APPLICATION/PERMIT TO CONSTRUCT, OPERATE AND MAINTAIN UTILITY FACILITIES ON HIGHWAY RIGHT-OF-WAY

MILWAUKEE COUNTY
SHERIFF'S OFFICE
LICENSE PLATE READER
INSTALLATION

INSTALLATION OF NEW POLE IN EXISTING RIGHT OF WAY SUPPORTING
LICENSE PLATE READER CAMERA FOR THE MILWAUKEE COUNTY
SHERIFF'S OFFICE.

SITE PLAN

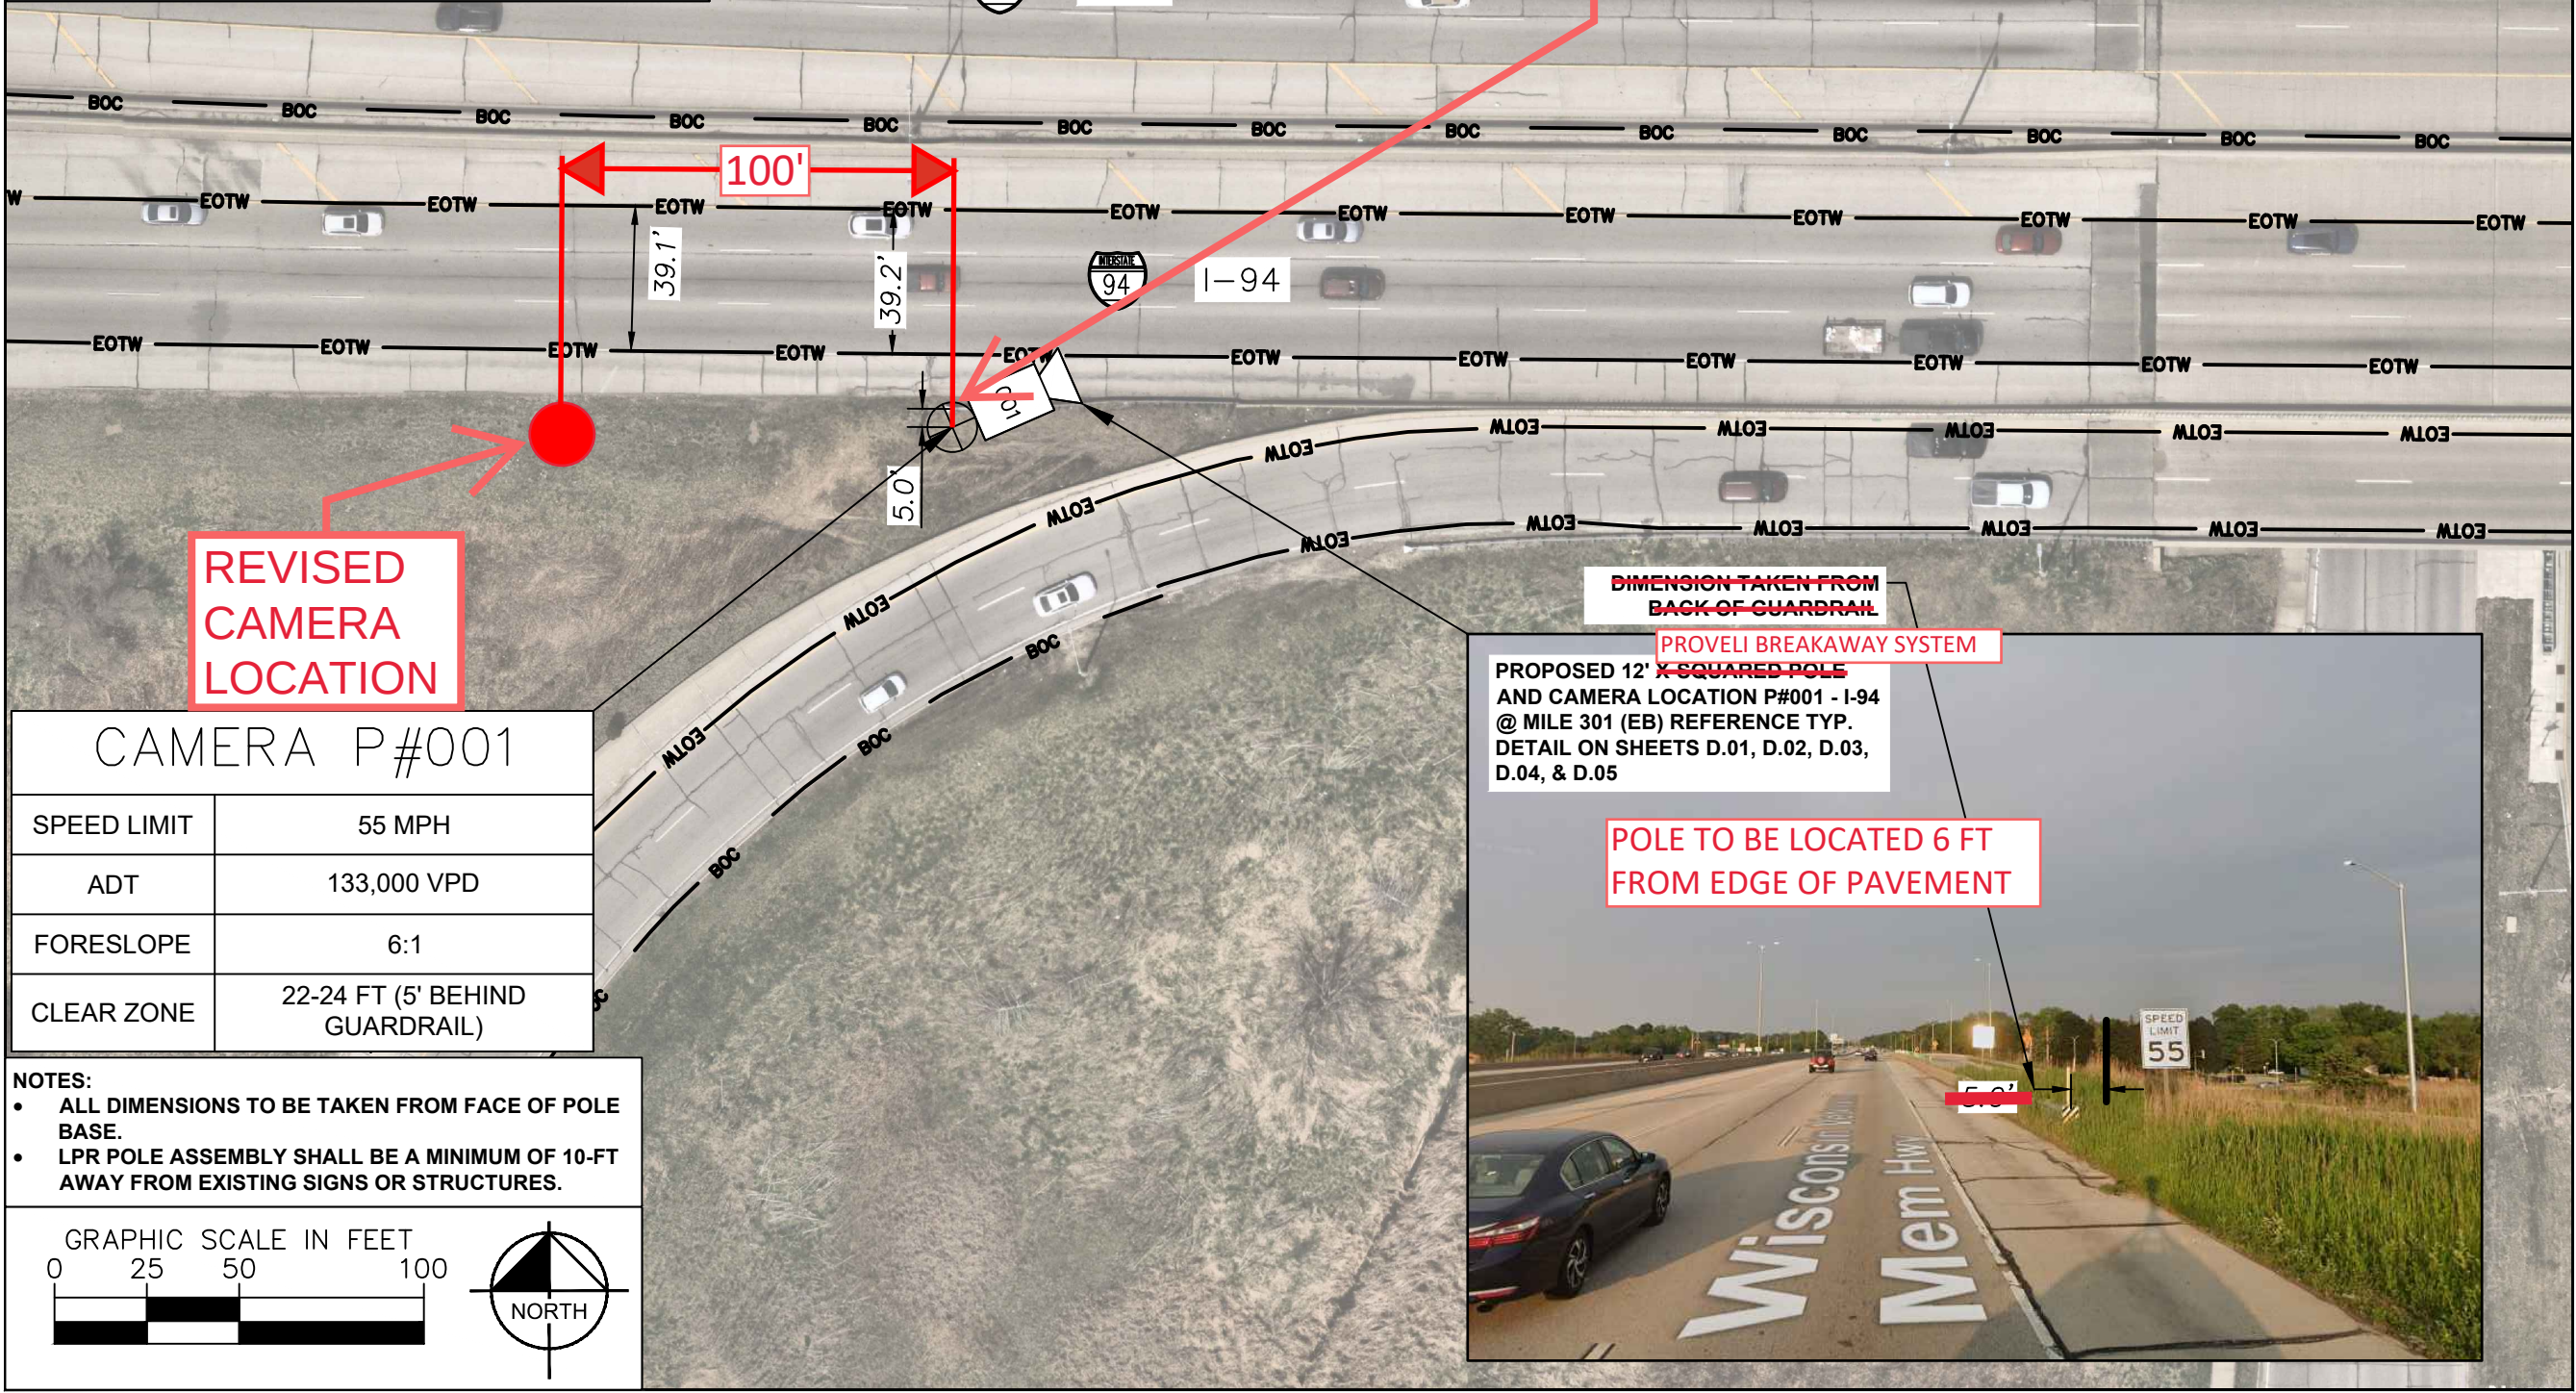
ADJUST TRAFFIC CONTROL 100 FT WEST DUE
TO REVISED LOCATION OF POLE/CAMERA AS
SHOWN ON THE SITE PLAN.

The proposed location is currently behind the beamguard end treatment. I'd like to see the pole moved 100 ft to the west. If this location is acceptable to you, let me know and I will make the adjustments to the plans.

CAMERA	NUMBER & LOCATION	COORDINATES (N,W)
	P#001 - I-94 @ MILE 301 (EB)	Revised Location: Lat 43.024275° Long = -88.108931° 43.024262213625825, 88.10853145003602

Yes please proceed with recommended location-
